**YANKEE ATOMIC ELECTRIC COMPANY**  
49 Yankee Road, Rowe, Massachusetts 01367

November 16, 2006  
BYR 2006-107

Subject: License Termination Plan Biennial Update

## Summary Listing of November 2006 Changes to YNPS LTP

### Figure 1-2 Historical Site Design

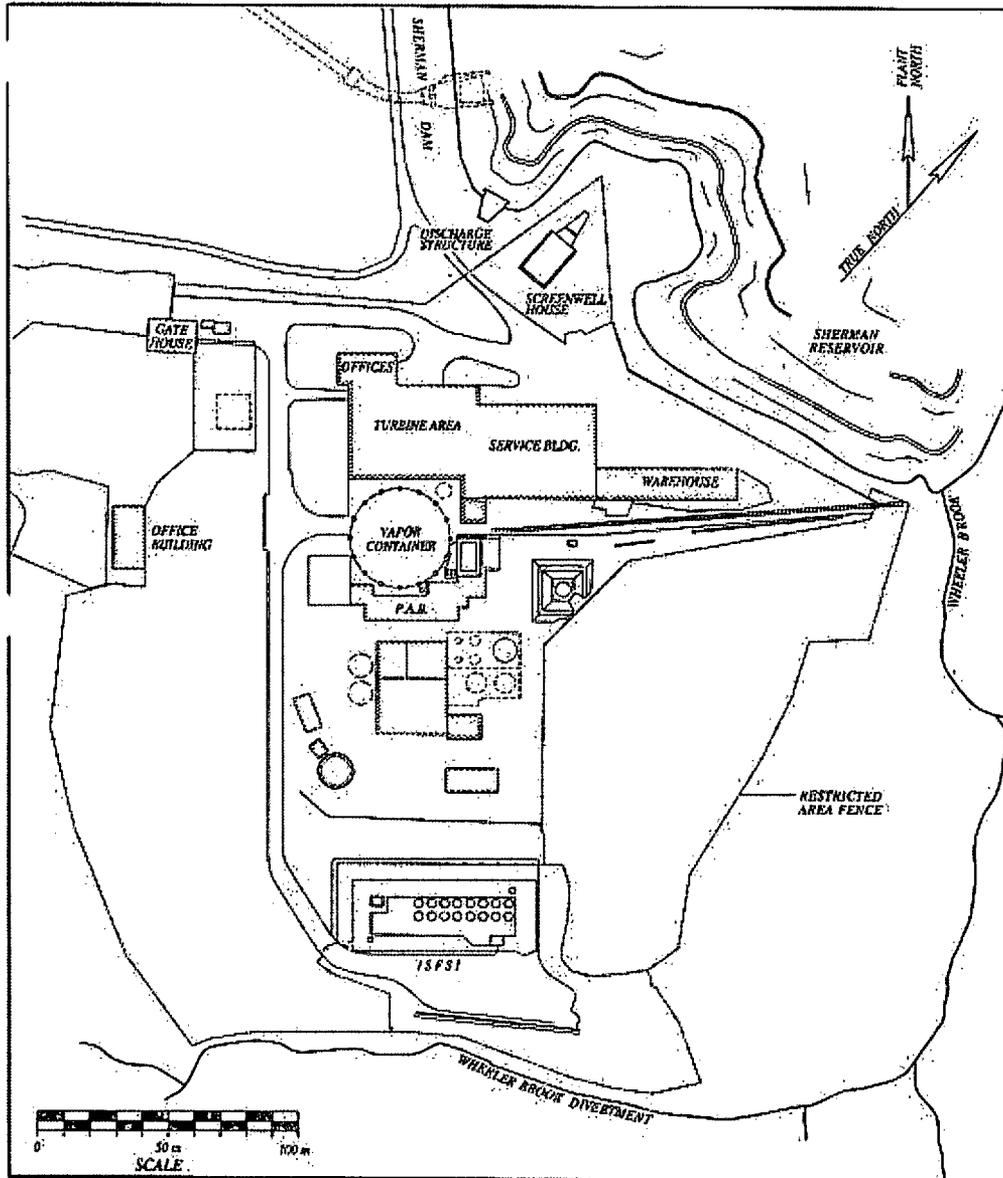
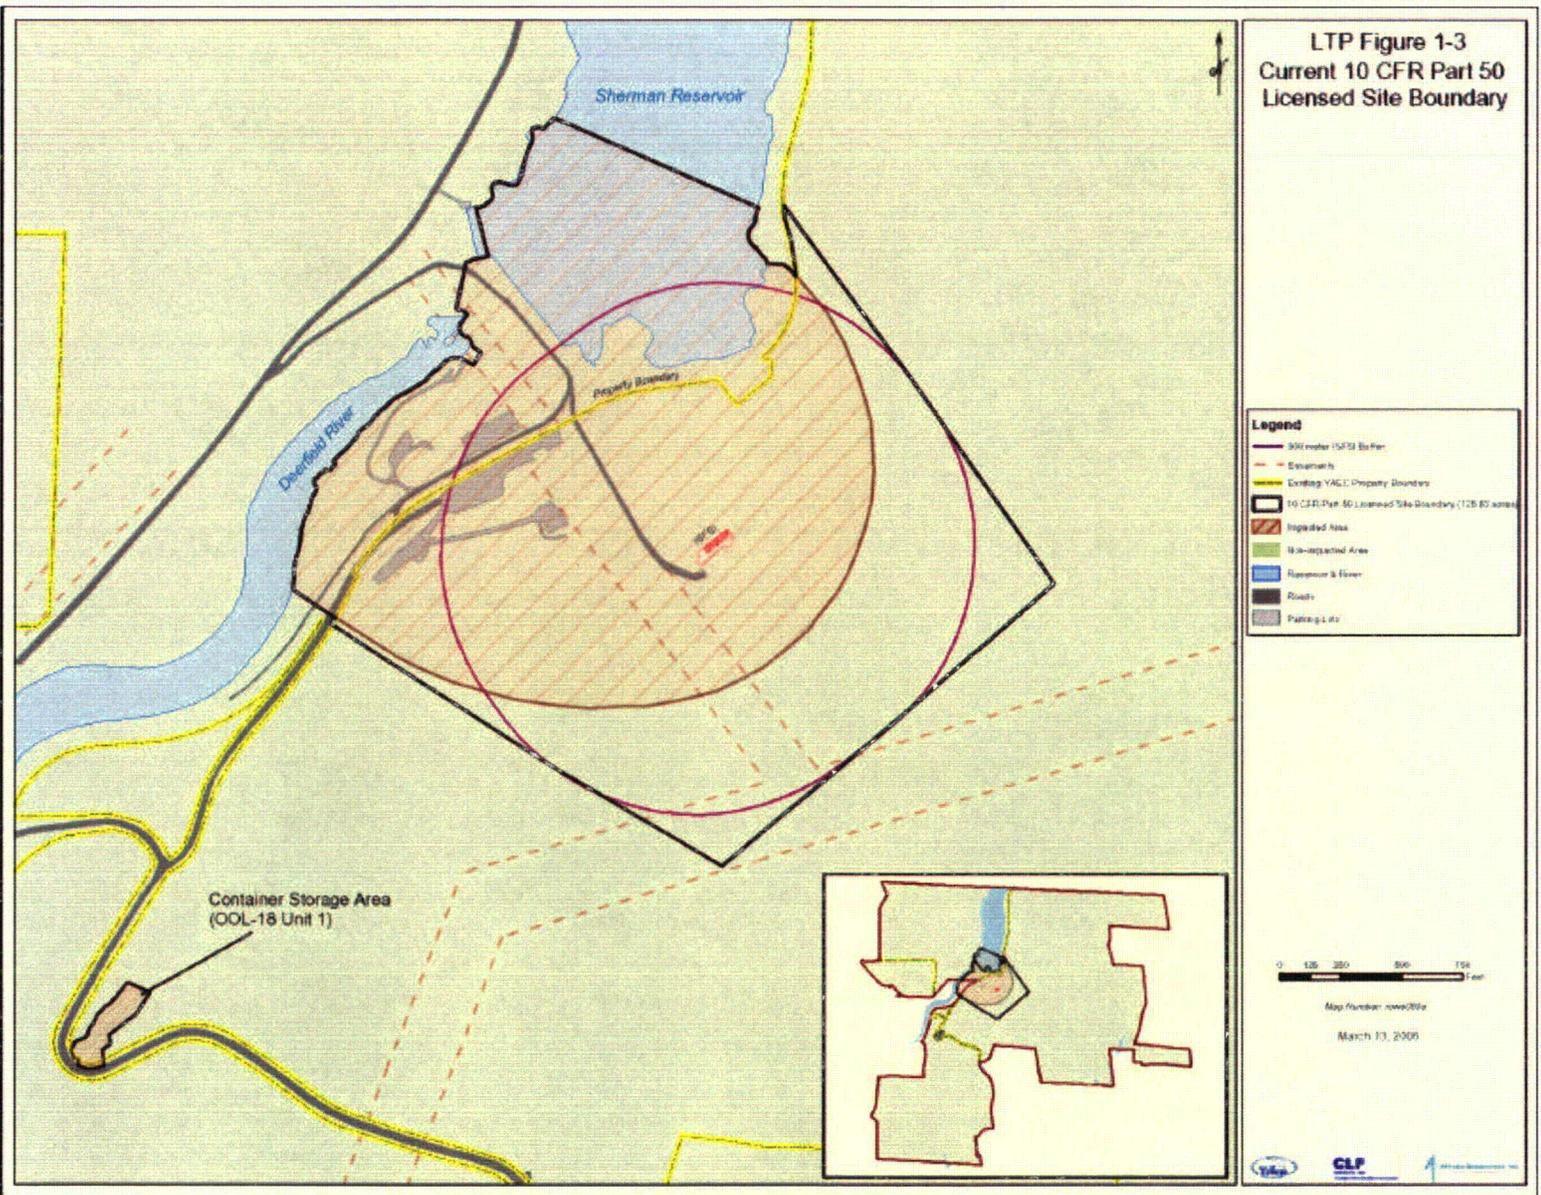
Section Number	Description of Change
Front Matter	Change to List of Effective Pages to reflect Revision 2.
Section 1	Change (LBDCR 06-02) to Figure 1-1 to identify figure as the <i>historical</i> site boundary, change to Figure 1-2 to identify figure as <i>historical</i> site design, addition of Figure 1-3 to show new site boundary as allowed by approved partial site release, and addition of page 1-16 because of new figure.
Section 2	No change to this section.
Section 3	No change to this section.
Section 4, including Appendix 4A	No change to these sections.
Section 5	Change (LBDCR 06-03) to revise criteria used to determine when resurveys, post-FSS, are required. Change (LBDCR 06-11) to acknowledge that survey area limits are "suggested" rather than being rigid limits.
Section 6	Change (LBDCR 06-04) to correct typographical and printing errors.
Appendix 6A	Change (LBDCR 06-04) to correct typographical and printing errors.

LBDCR  
06-02
